ST. TAMMANY PARISH

Addendum No.: 2

Bid#: 24-35-2

Project Name: Diversified Water Well Pretreatment System

SHEET NO.
S-014
SHEET 49 OF 90

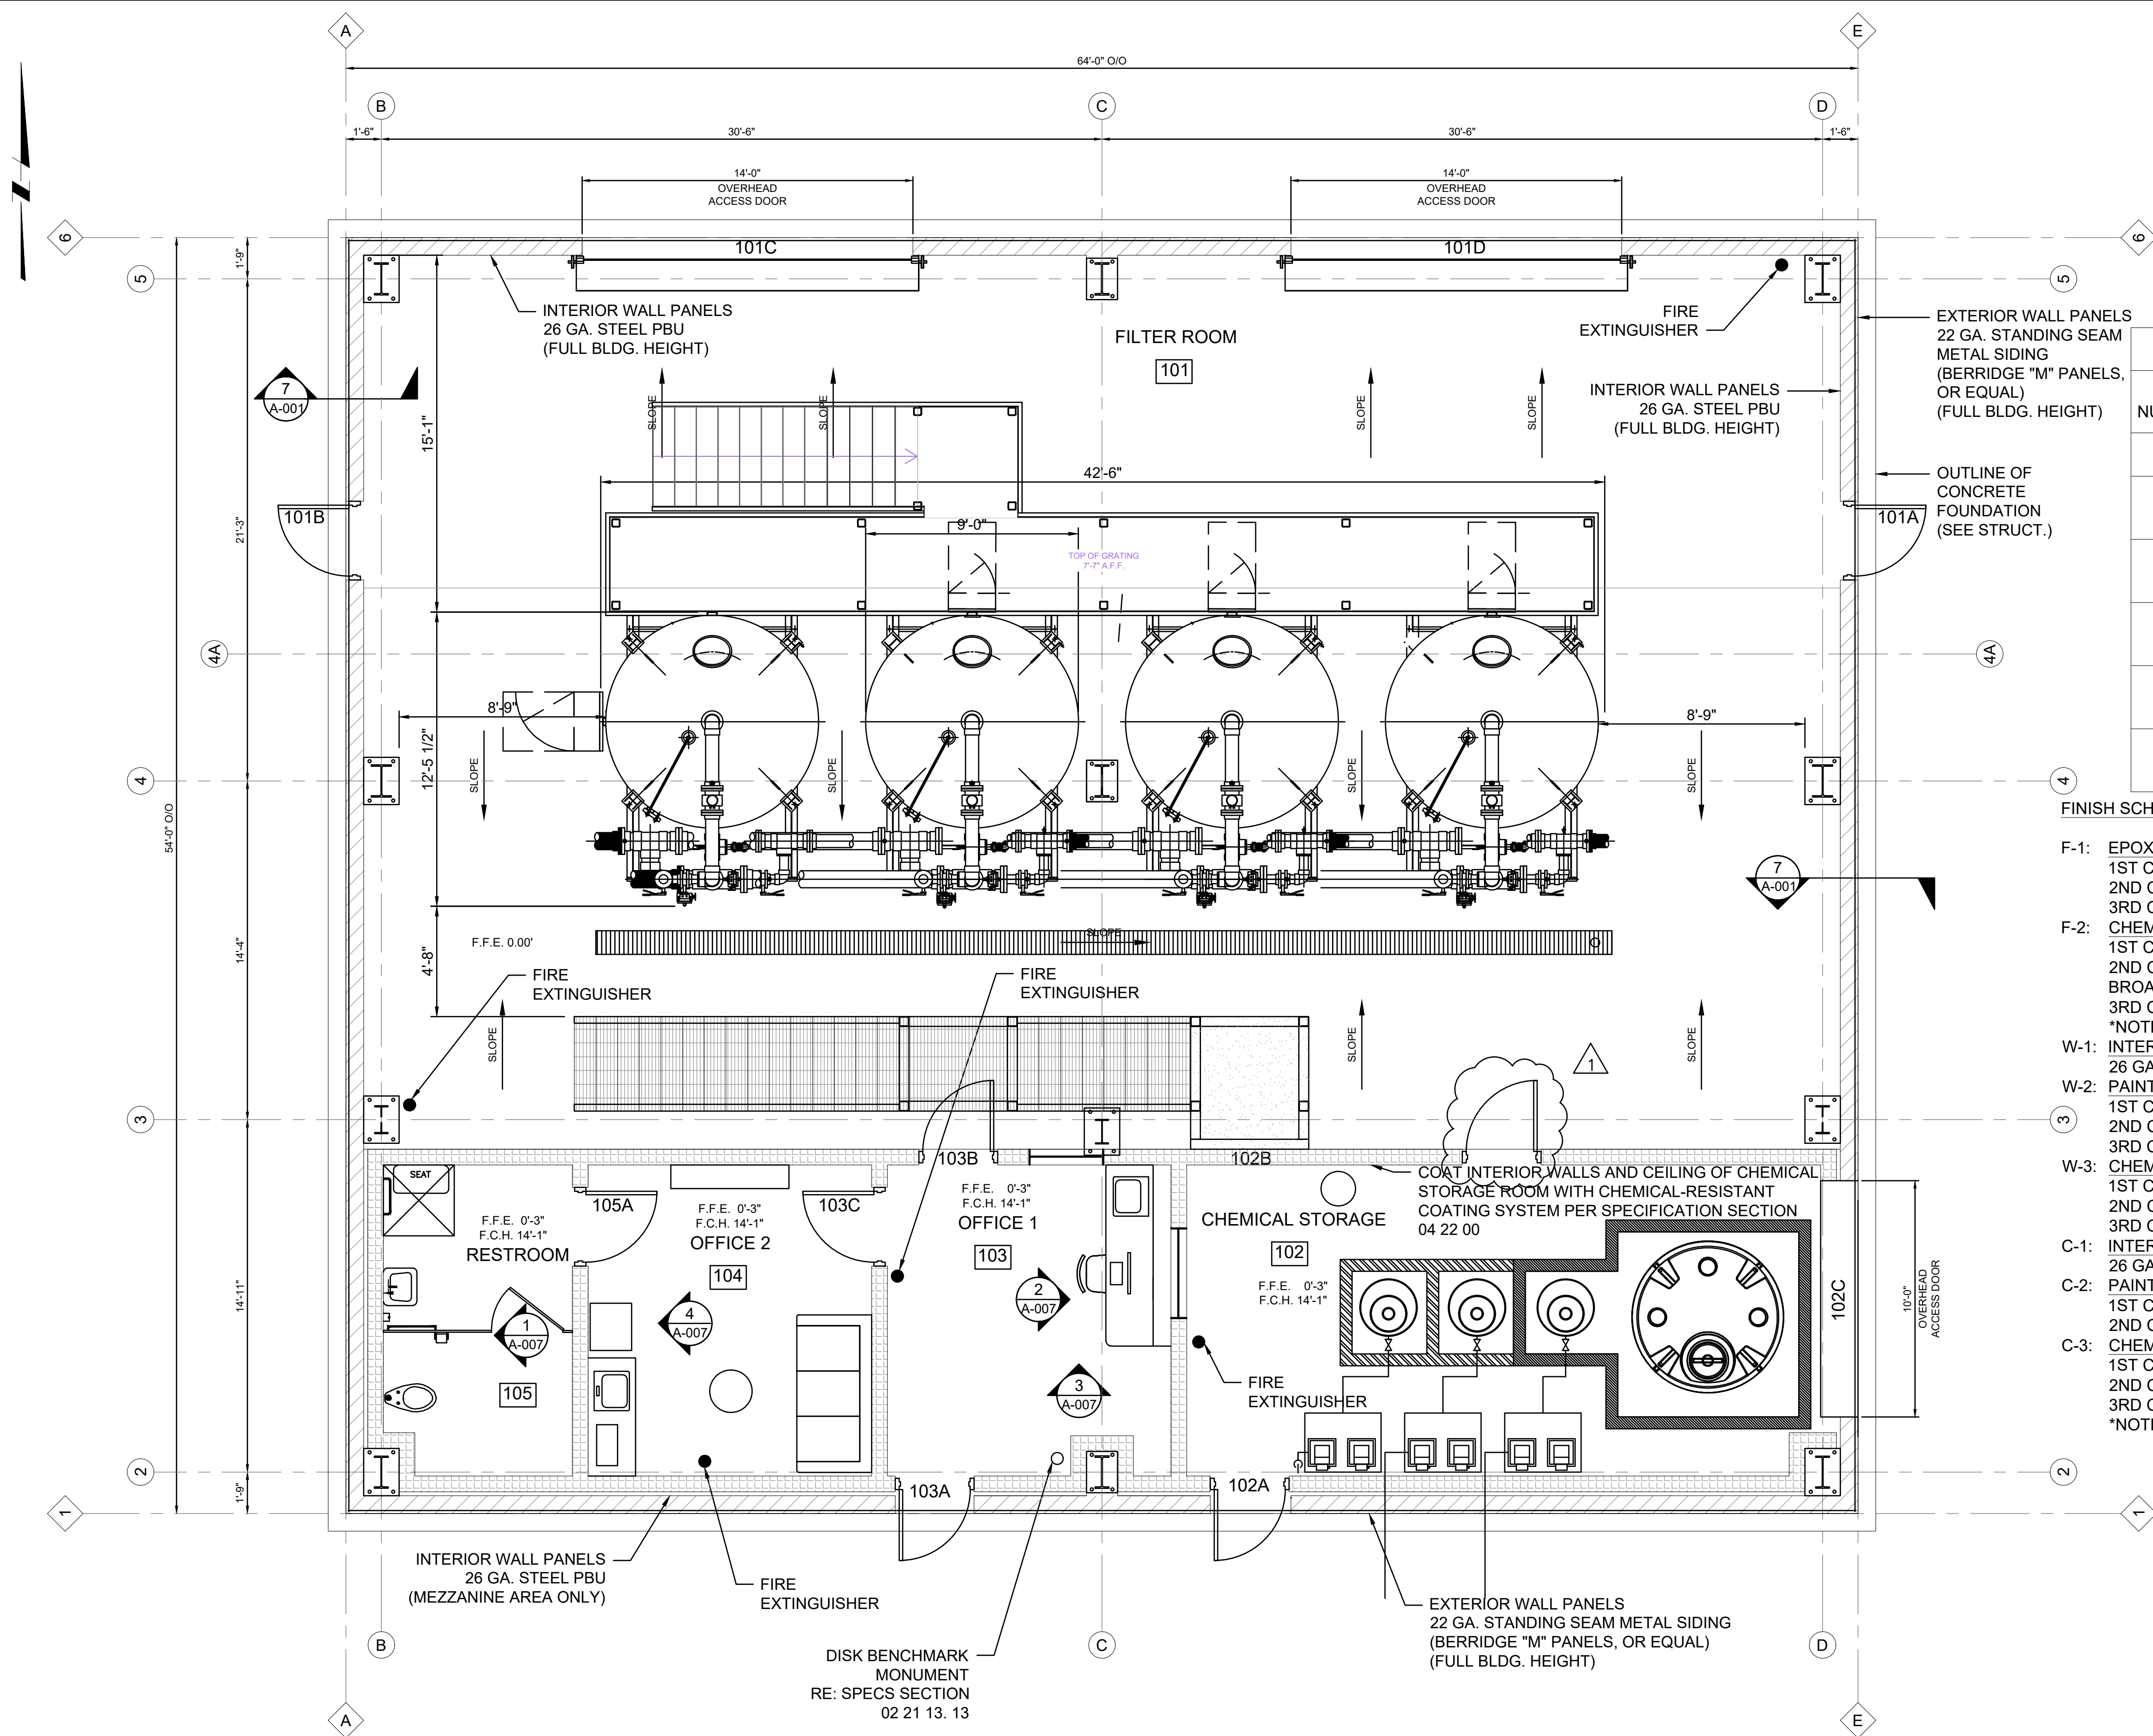
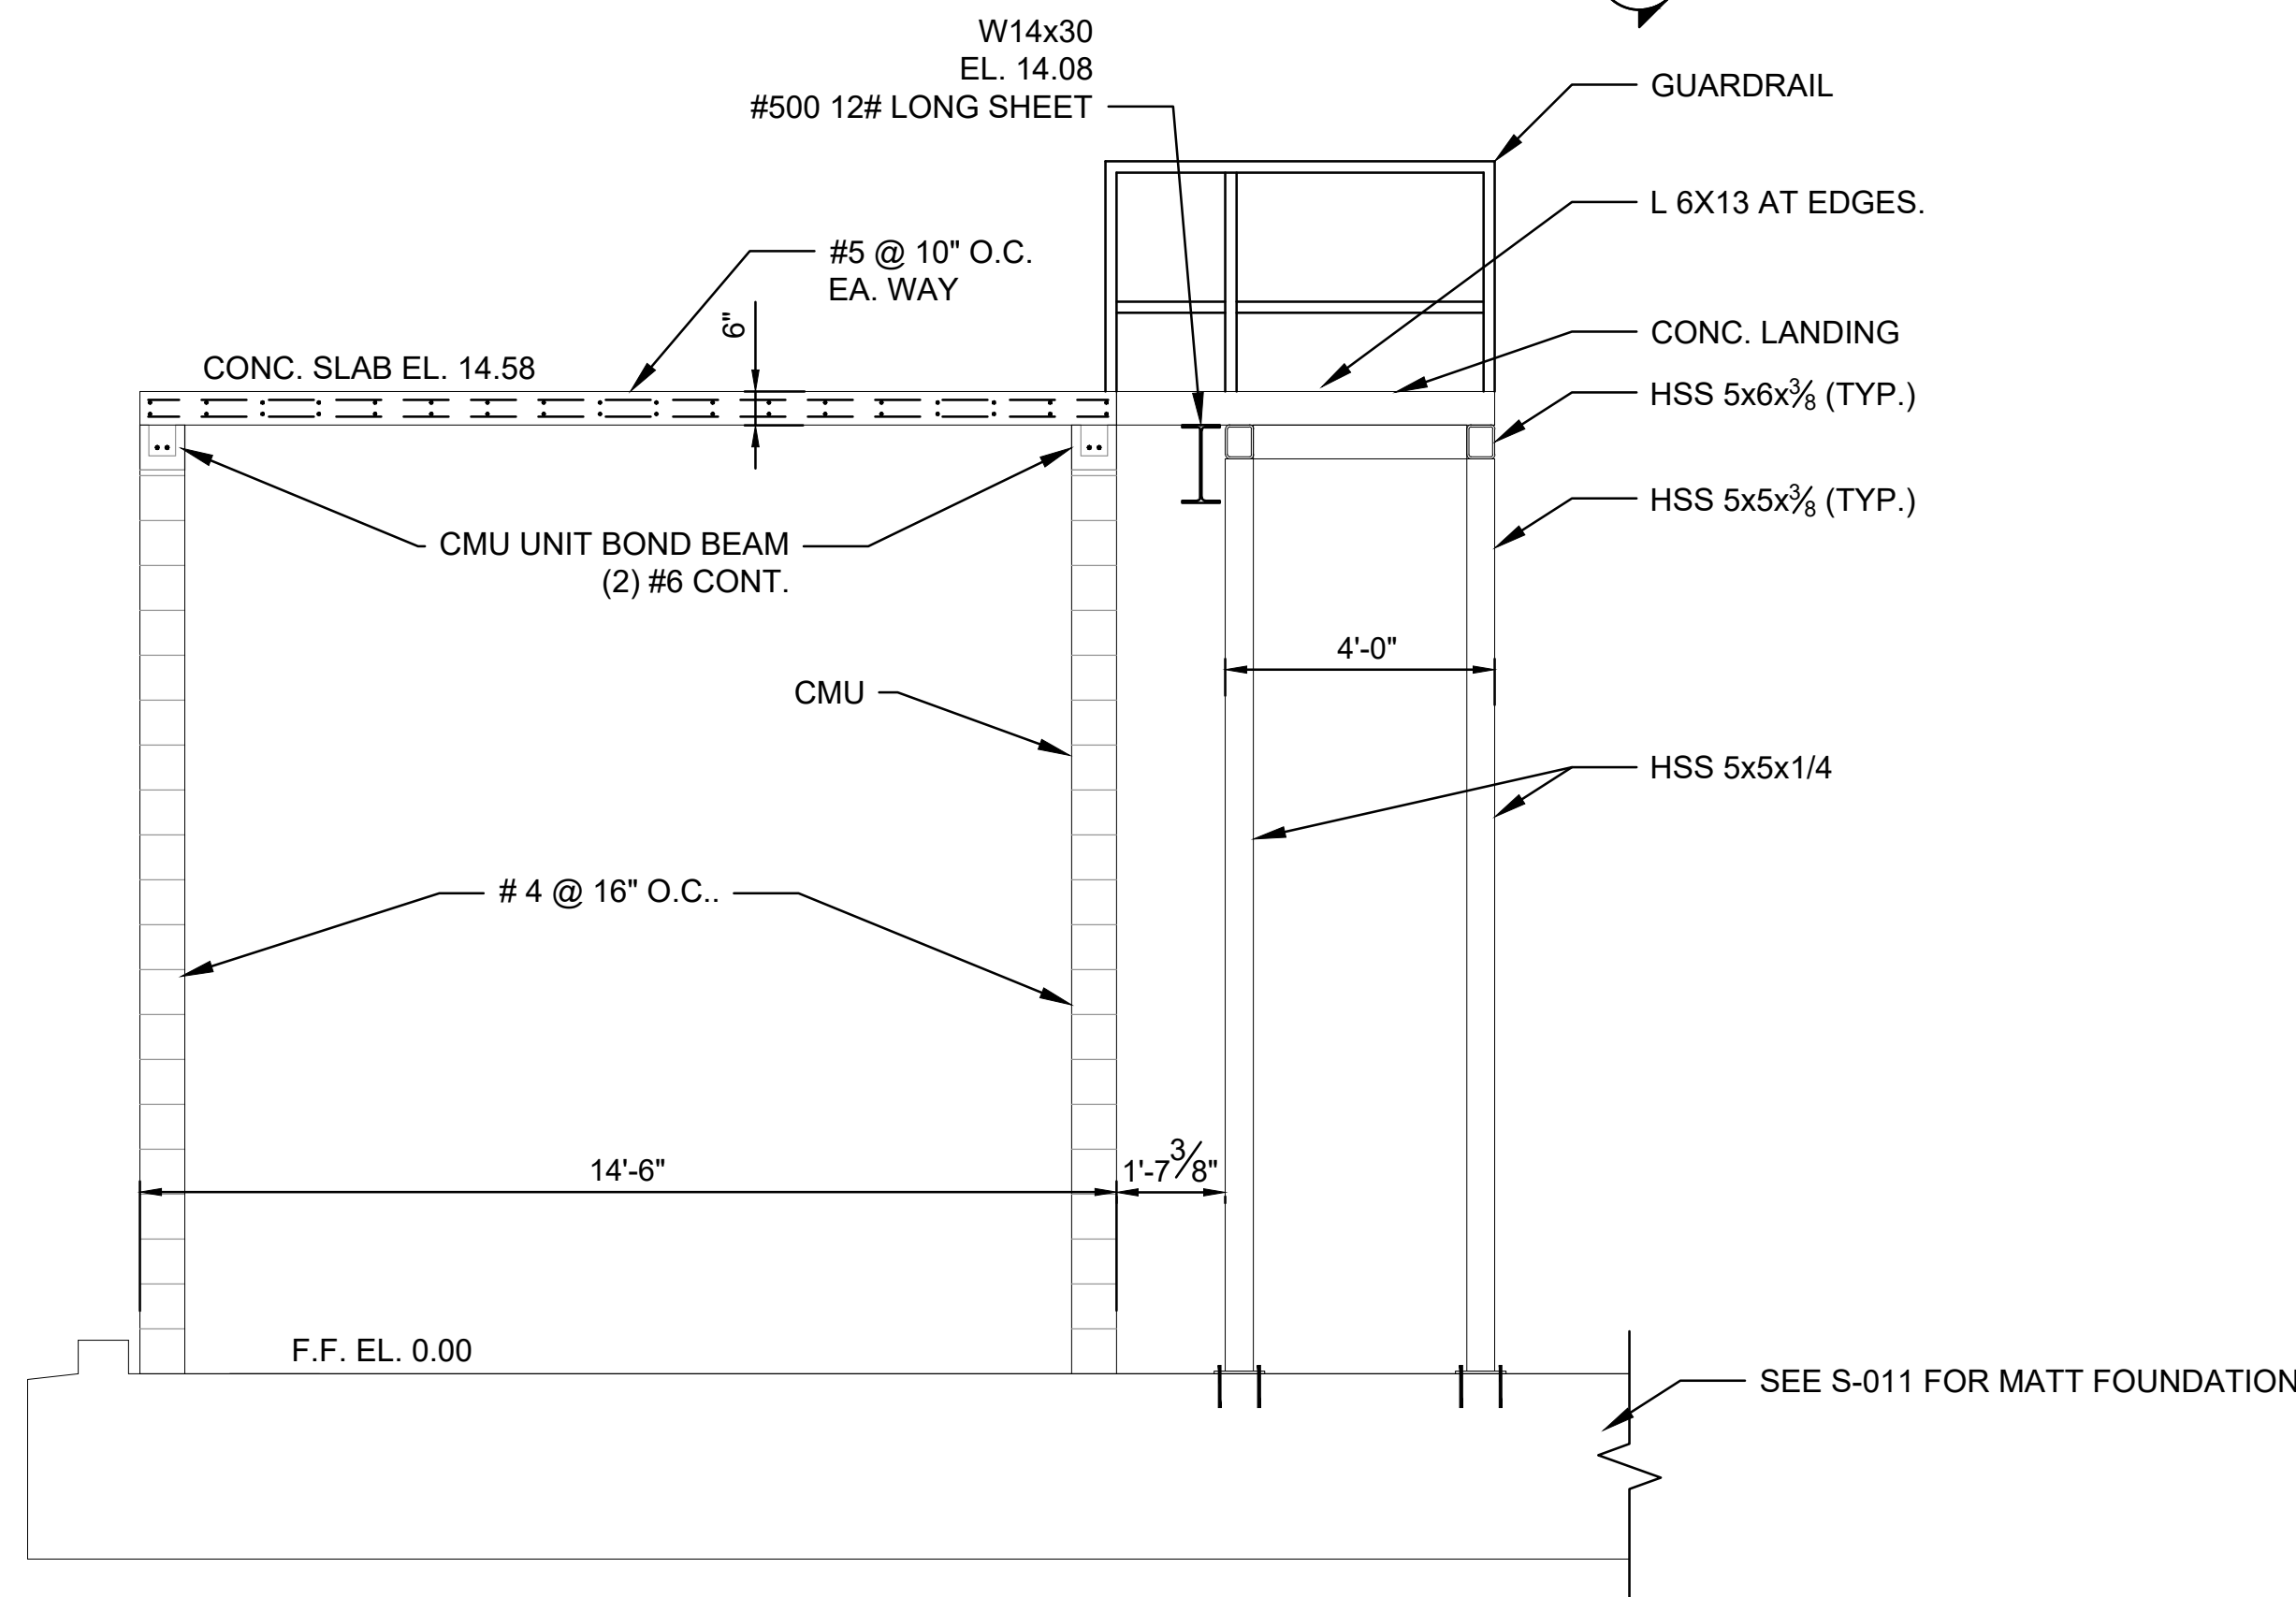
39. **Replace** Plan Sheet S-014 CMU Wall North Elevation with the attached revised Sheet S-014, revised to include the adjusted Door #102B location.
40. **Replace** Plan Sheet A-002 Floor Plan with the attached revised Sheet A-002, revised to include Room Finish Schedule and adjusted location of Door #102B in Chemical Storage Room.

Question 31: Please confirm the rebar sizing in the CMU Block, A/S-014 Shows No. 4 at 16" OC, Sheet S-015 – Detail B Shows No. 6 at 48" and the Bond Beam Detail Shows No. 5 at 16" OC.

Answer 31: Vertical Reinforcement for CMU Blocks shall be #4 bars at 16" O.C. Bond Beam reinforcement shall be two (2) #6 horizontal bars and #4 stirrups at 12" O.C.

SHEET NO.
A-002
SHEET 59 OF 92

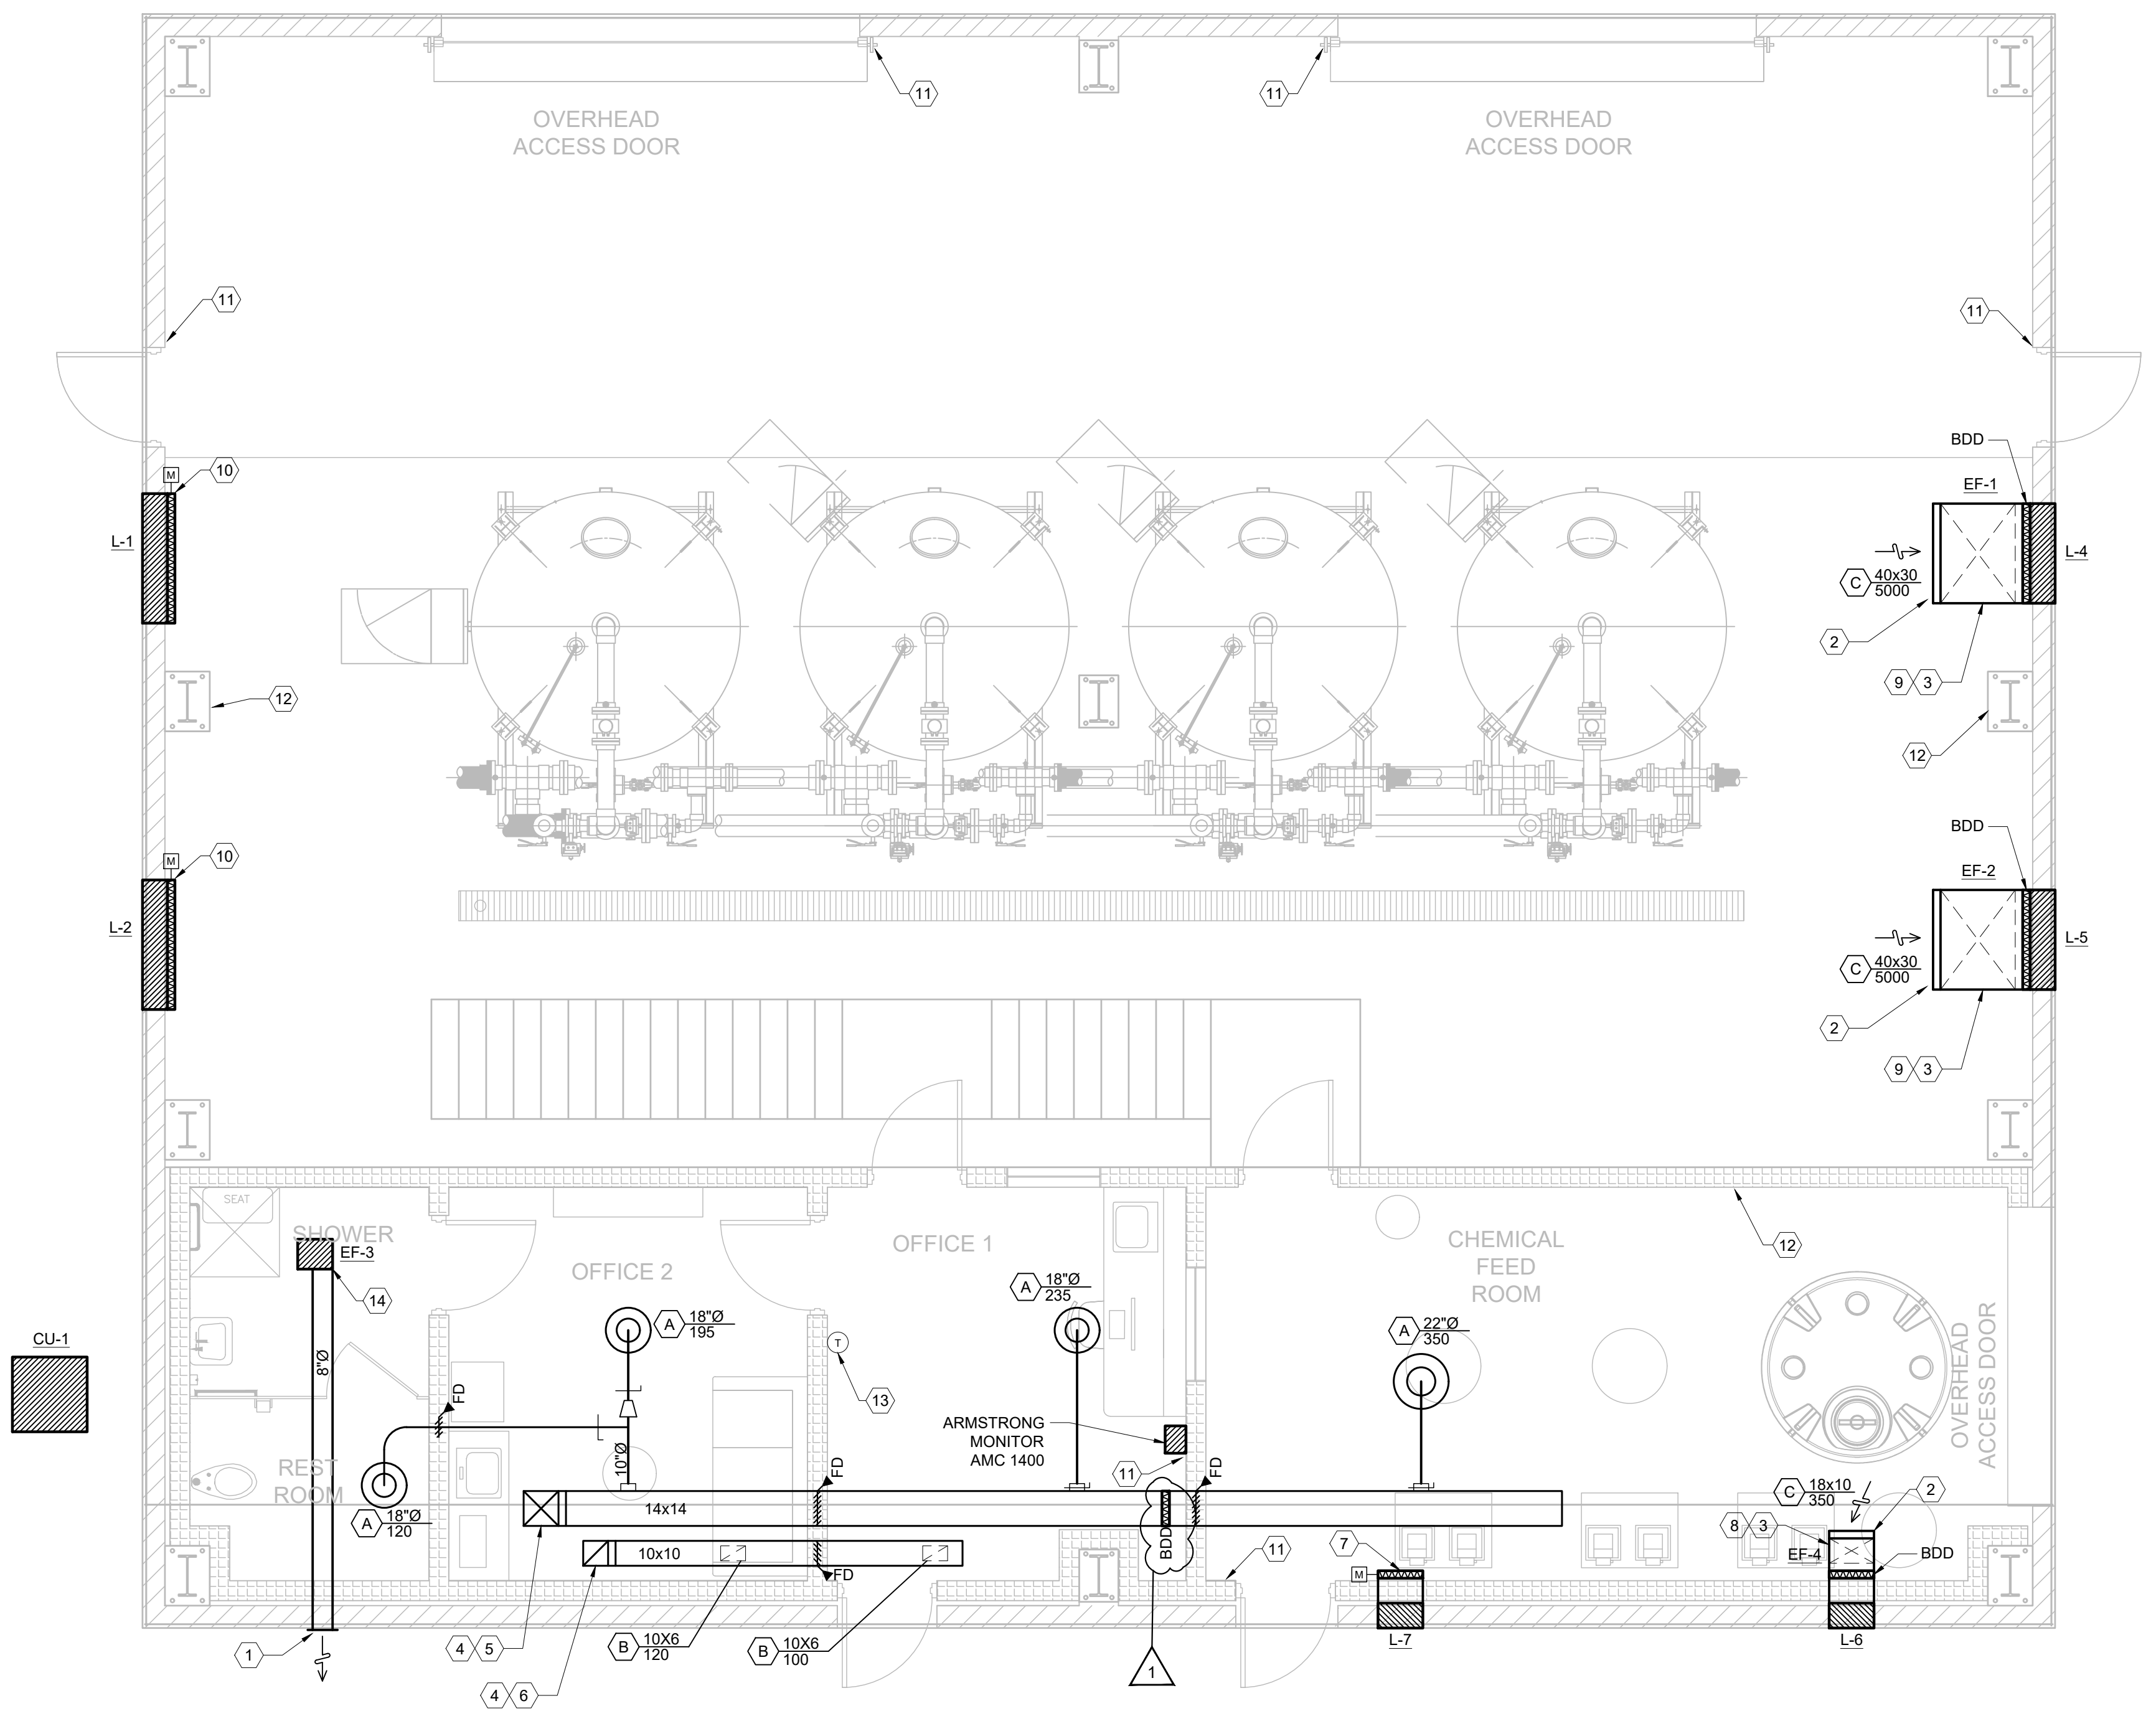
Question 28: Please issue a finish schedule for Rooms 101, 102, 103, 104 & 105.

Answer 28: Refer to Finish Schedule on revised Plan Sheet A-002, added by addendum herein.
